# Access Compliance Report

## Public Rights-of-Way

### (Curb Ramps)

Intersection ID: 11958	Main Street: E_16TH_ST	Cross Street: SEIGLE_AV	Location: S
ADA ID: E1EDE08C0069	Ramp Type: Perp	Initial Pass/Fail: Fail	Overall Compliance: No
		Severity Score: 8.75

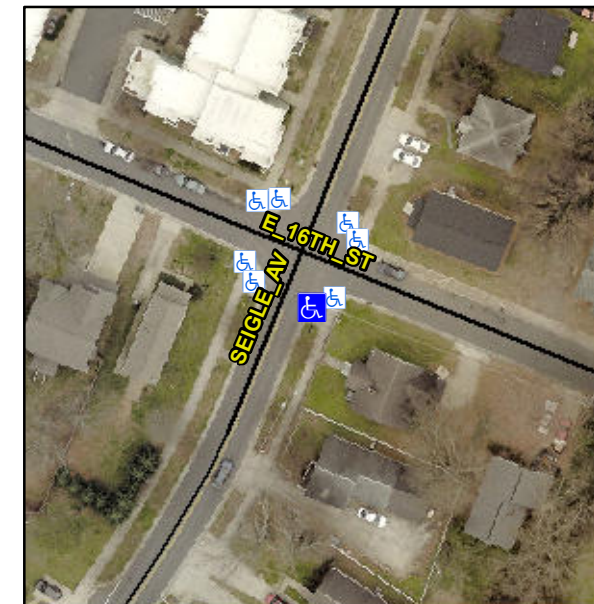
**Not Found, R304.5.1**

Compliance	Description	Data	Compliance	Description	Data
N/A	Ramp Length (in)	74.0	Yes	Ramp Slope (%)	6.3
No	Ramp Width (in)	47.5	Yes	Ramp XSlope (%)	0.9
N/A	Flare Type LT	N/A	N/A	Flare Type RT	N/A
N/A	Flare Slope LT (%)	N/A	N/A	Flare Slope RT (%)	N/A
N/A	Flare Traversable LT?	N/A	N/A	Flare Traversable RT?	N/A
N/A	Landing Length (in)	N/A	N/A	DWS Provided?	N/A
N/A	Landing Width (in)	N/A	N/A	DWS Contrast?	N/A
N/A	Landing Slope (%)	N/A	N/A	DWS Length (in)	N/A
N/A	Landing X Slope (%)	N/A	N/A	DWS Full Width?	N/A
N/A	Landing Curb? (Y/N)	N/A	N/A	DWS Offset (in)	N/A
N/A	Shared Landing?	N/A			
N/A	Gutter Ponding?	N/A	N/A	Gutter Slope (%)	N/A
N/A	Gutter Lip Ht (in)	0.5	N/A	Gutter X Slope (%)	N/A
N/A	Painted X Walk1?	No	N/A	Painted X Walk2?	N/A
	X Walk 1 Direction	To NW		X Walk 2 Direction	N/A
N/A	X Walk 1 Width (in)	N/A	N/A	X Walk 2 Width (in)	N/A
	X Walk 1 Slope (%)	0.6		X Walk 2 Slope (%)	N/A
	X Walk 1 X Slope (%)	1.2		X Walk 2 X Slope (%)	N/A

**Remove & Replace Entire Ramp.**
